RE: St Luke's East Hospital MRI REPLACEMENT
Permit No: PRCOM20202038
80 NE Saint Luke's Blvd,
Lee's Summit, MO 64086

The following is our response to your review of the referenced project dated July 29, 2020

Building Plan Review

2 FIRST FLOOR POWER PLAN
1/4" = 1'-0"

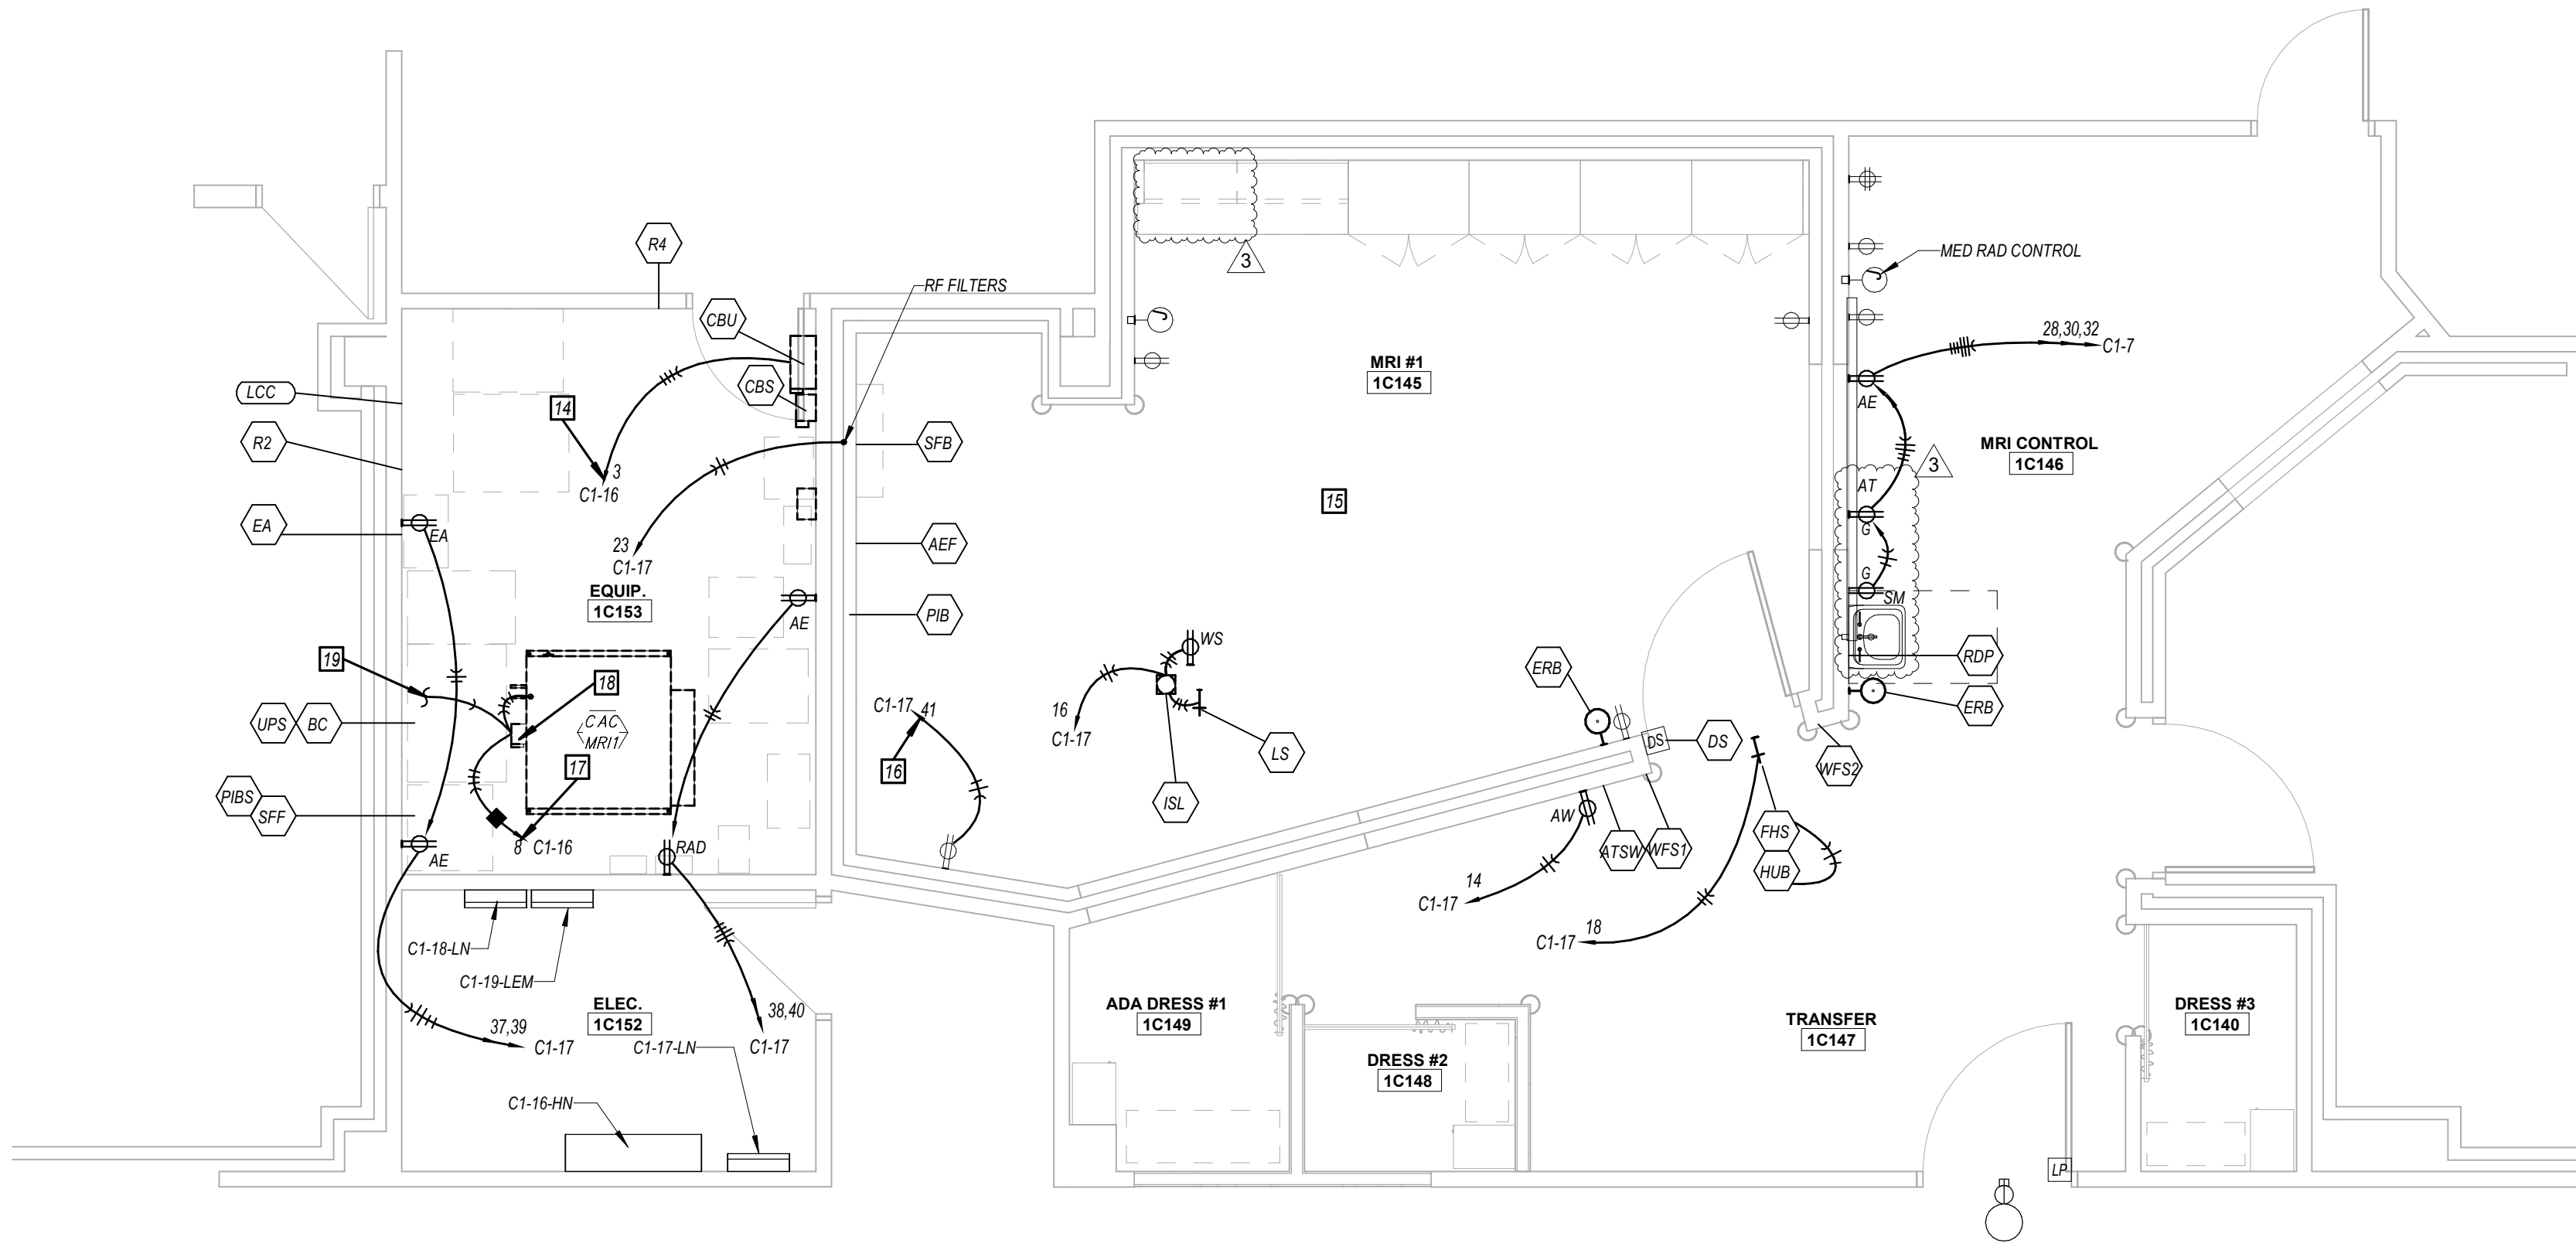
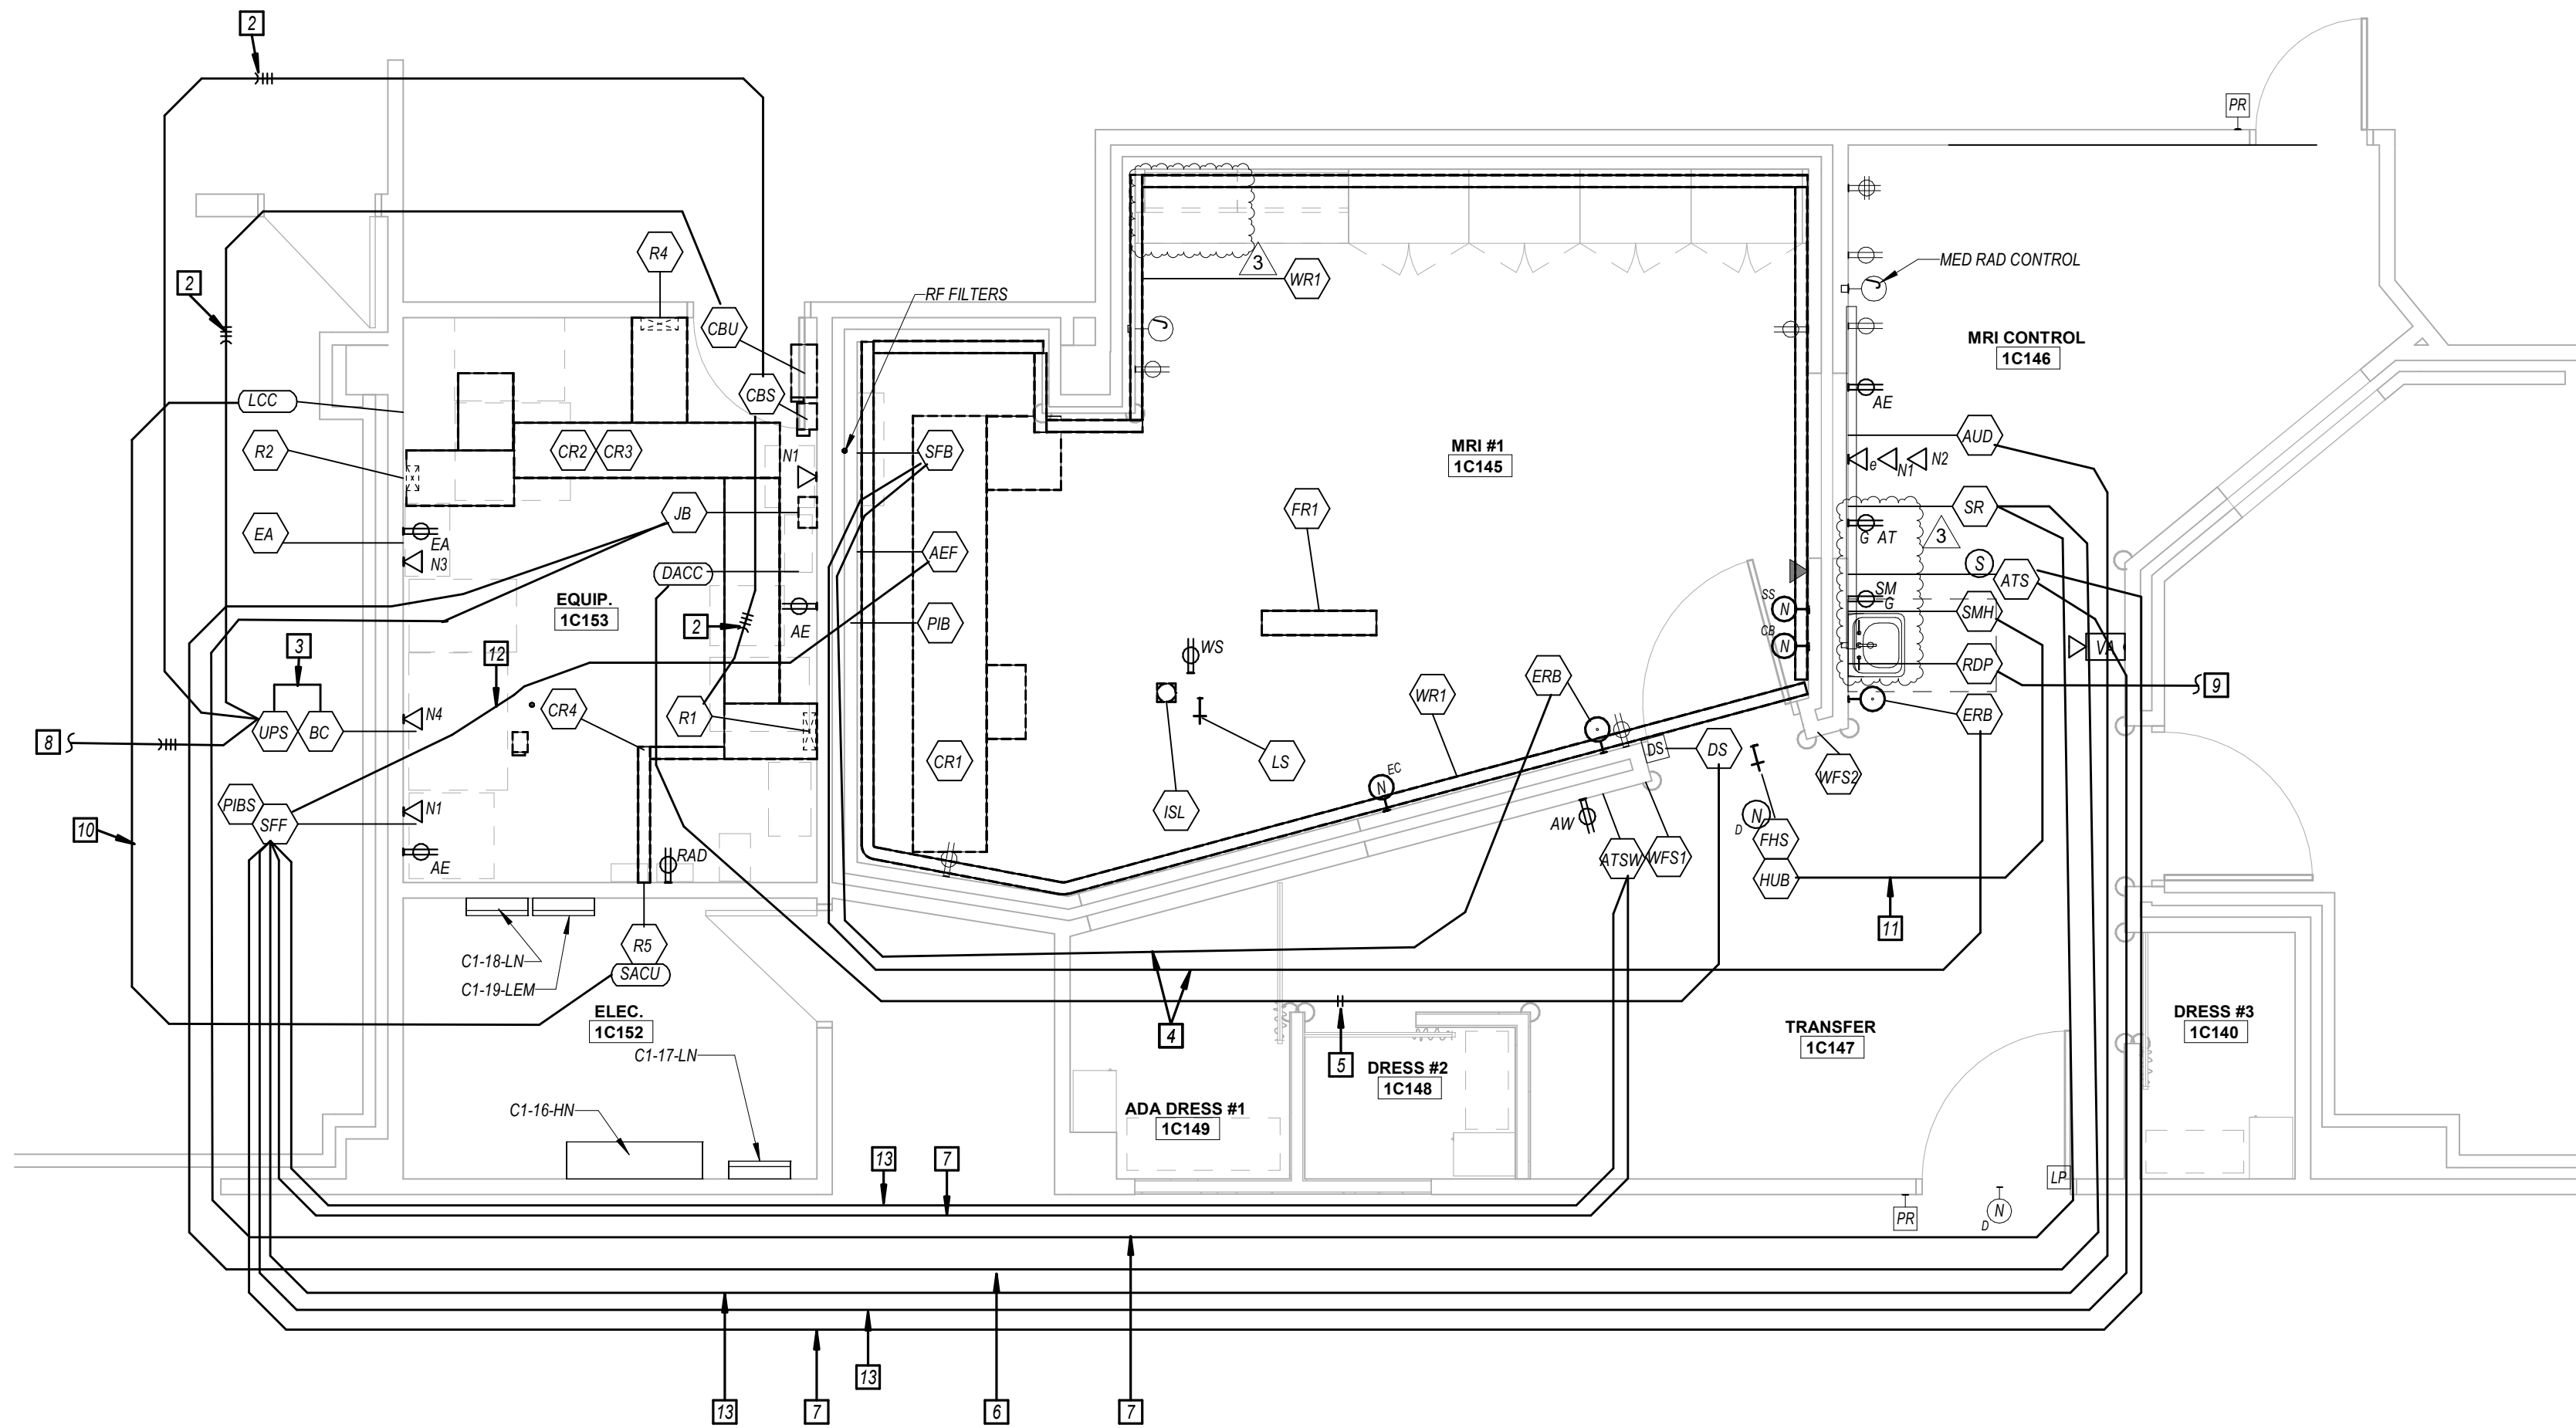
Action required: Modify drawings to show that all circuits in patient care areas will have redundant ground system.

1. *ADDED Electrical Power General Note #7 to clarify grounding requirements. All changes have been clouded on revised sheet EP2.1, rev. 3.*

2. *REVISED location of sink, and REVISE two (2) receptacles within 6' of new sink location to be GFCI type. All changes have been clouded on revised sheet EP2.1, rev. 3.*

3. *REVISED keyed notes #9 and #11 to coordinate exact locations of Philips equipment with Philips, to allow for installation of new sink. All changes have been clouded on revised sheet EP2.1, rev. 3.*
